CITY PLANNING COMMISSION

APPLICATION: A. Special Permit to construct a 129 seat fast food restaurant with drive-through window on 0.87 vacant acres in the General Commercial (C-2) Zone.

APPLC. NO. P87-023

MEETING DATE January 22, 1987

SITE PLAN

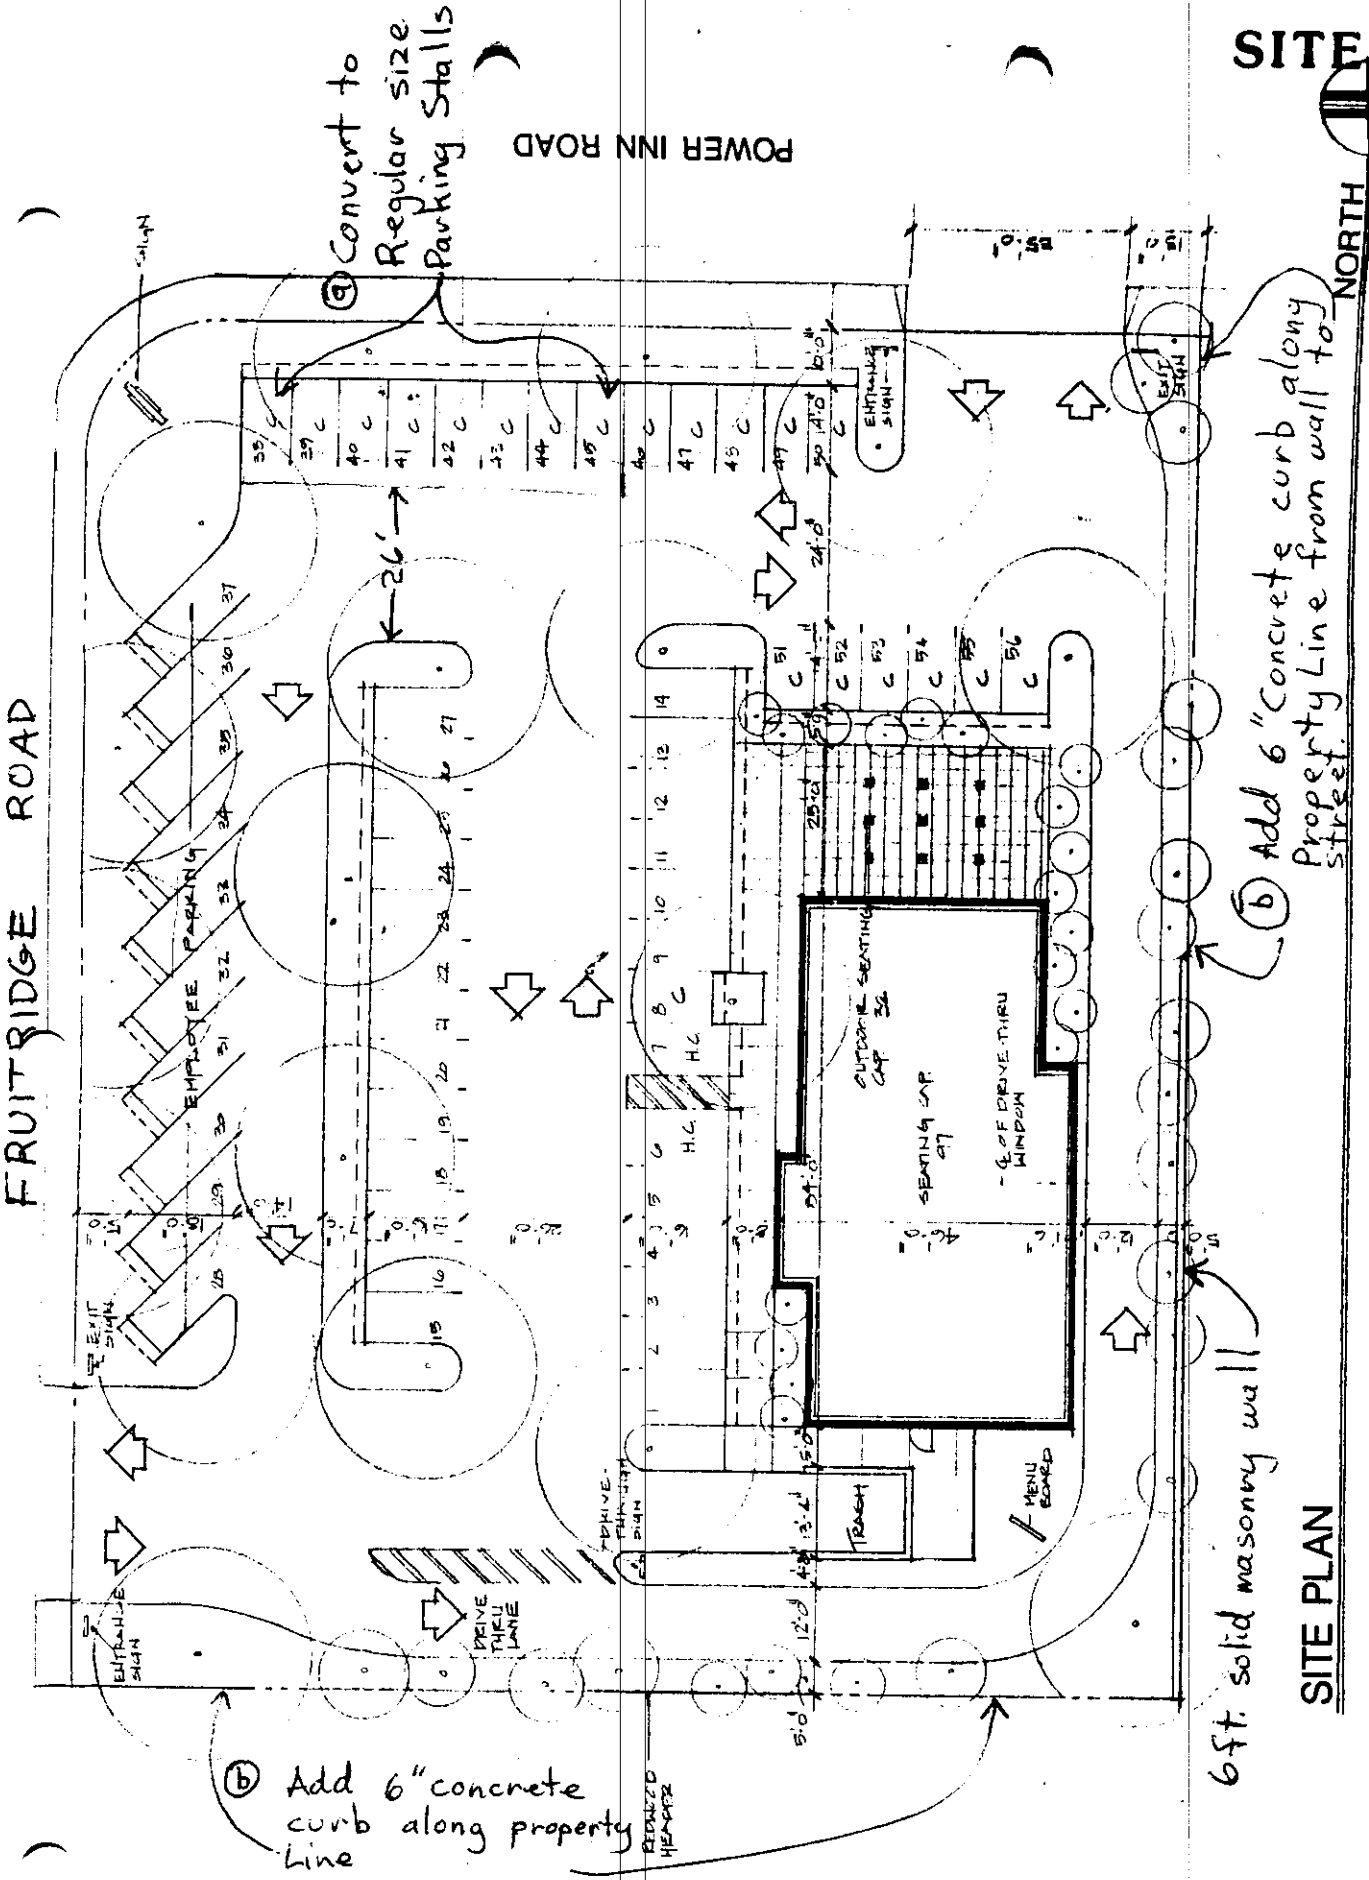
- a. The site plan proposes a total of 56 parking spaces, 20 of which are compact spaces and two handicapped. The compact total maximum is 17 utilizing 30 percent of the provided 56 total spaces. Three spaces need to be expanded to regular size dimensions. Staff recommends that spaces 38 to 45 be extended to 16 feet in length with two feet of vehicle overhang since adequate backout vehicle parking of 26 feet remains to the landscaped tree well to the west. (Refer to Site Plan).

- b. The applicant's plans show a two by eight inch redwood header board as the landscape retainer along the west property line. Staff recommends a more permanent landscape retainer in the form of a six inch raised concrete curb. No fencing is proposed along the west property line. Staff recommends that shrubbery be placed in the landscape strip to provide a visual screen and boundary to the western property line and along the southern property line where the wall is not shown.

Convert to Regular size Parking Stalls

⑥ Add 6" concrete curb along Property Line from wall to street

⑥ Add 6" concrete curb along property line

6ft. solid masonry wall

1. Revised landscaping, shading, and irrigation plans for the site shall be submitted for staff review and approval prior to issuance of building permits.
2. A six foot high decorative wall constructed of color and materials similar to the main structure shall be shown on a revised site plan adjacent to the residential zone.

8. Parking lot stalls 38 to 45 shall be redesigned and extended to 16 feet in length with two feet of vehicle overhang on the revised site plan.
9. A six inch raised concrete curb shall be installed along adjacent property lines, West and South in place of a two by eight inch redwood header board and shown on the revised site plan.

LANDSCAPE PLAN

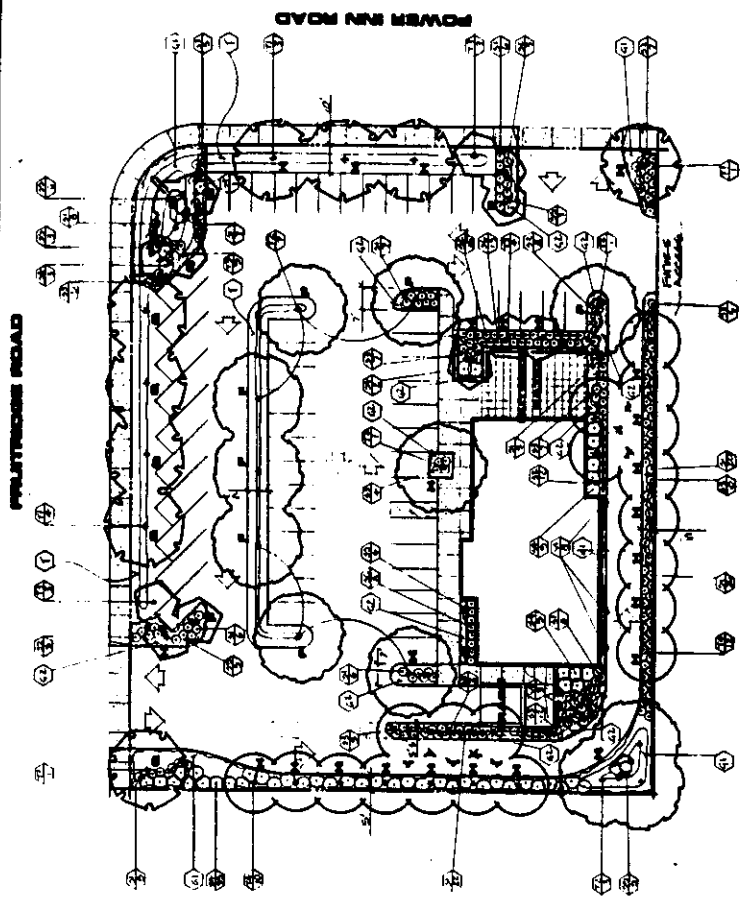
- 1). All exposed earth areas should be covered with living ground cover.
- 2). In order to prevent headlights from affecting drivers on either street frontage and since the landscape strip adjacent to the roadways is not deep enough to allow three to four foot high berming, staff recommends the use of intensive shrubbery adjacent to the vehicle parking area no higher than three to four feet in lieu of a berm of three to four feet in height. Groundcover under the shrubs shall be living in the setback area off the roads. Irrigation systems should allow a two foot vehicle overhang adjacent to the curb edge.

- 3). The parking lot will be required to meet the City Tree Shading Ordinance requirement of fifty percent coverage within 15 years of planting.
- 4). The landscape strip adjacent to the south property line wall will be only three feet in depth. An additional two feet is necessary in order to provide adequate area for tree wells. A total of four feet of landscape area is necessary.

10. The revised landscape plan shall show intensive shrubbery where parking stalls face into adjacent roadways so that headlights do not effect oncoming traffic. (Ordinance requirement)

11. The landscape strip adjacent to the south property line shall be increased to a total of for feet of landscaping to provide adequate area for tree wells adjacent to the six foot high wall.
